# Access Compliance Report

## Public Rights-of-Way

### (Curb Ramps)

Intersection ID: 13149	Main Street: CENTRAL_AV	Cross Street: THE_PLAZA	Location: NE
ADA ID: 451EA7D7F799	Ramp Type: Perp	Initial Pass/Fail: Fail	Overall Compliance: No
Severity Score: 17.5			
Codes/Mitigation Info/Possible Solution		Field Measurements/Component Compliance

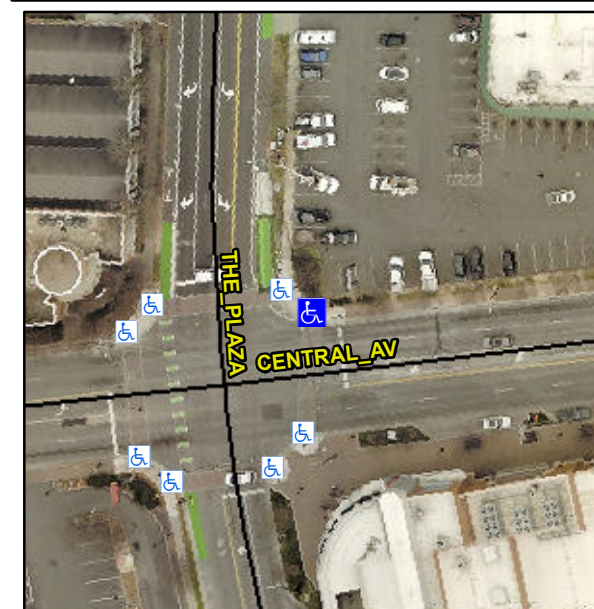
Possible Solutions:

**Remove & Replace Entire Ramp.**

PROW/ADA:

**Not Found, R304.5.1**

Compliance	Description	Data	Compliance	Description	Data
N/A	Ramp Length (in)	74.0	Yes	Ramp Slope (%)	7.7
No	Ramp Width (in)	34.0	Yes	Ramp XSlope (%)	1.5
N/A	Flare Type LT	N/A	N/A	Flare Type RT	N/A
N/A	Flare Slope LT (%)	N/A	N/A	Flare Slope RT (%)	N/A
N/A	Flare Traversable LT?	N/A	N/A	Flare Traversable RT?	N/A
N/A	Landing Length (in)	N/A	N/A	DWS Provided?	N/A
N/A	Landing Width (in)	N/A	N/A	DWS Contrast?	N/A
N/A	Landing Slope (%)	N/A	N/A	DWS Length (in)	N/A
N/A	Landing X Slope (%)	N/A	N/A	DWS Full Width?	N/A
N/A	Landing Curb? (Y/N)	N/A	N/A	DWS Offset (in)	N/A
N/A	Shared Landing?	N/A			
N/A	Gutter Ponding?	N/A	N/A	Gutter Slope (%)	N/A
N/A	Gutter Lip Ht (in)	N/A	N/A	Gutter X Slope (%)	N/A
N/A	Painted X Walk1?	Yes	N/A	Painted X Walk2?	N/A
	X Walk 1 Direction	To S		X Walk 2 Direction	N/A
N/A	X Walk 1 Width (in)	96.0	N/A	X Walk 2 Width (in)	N/A
	X Walk 1 Slope (%)	1.3		X Walk 2 Slope (%)	N/A
	X Walk 1 X Slope (%)	1.4		X Walk 2 X Slope (%)	N/A
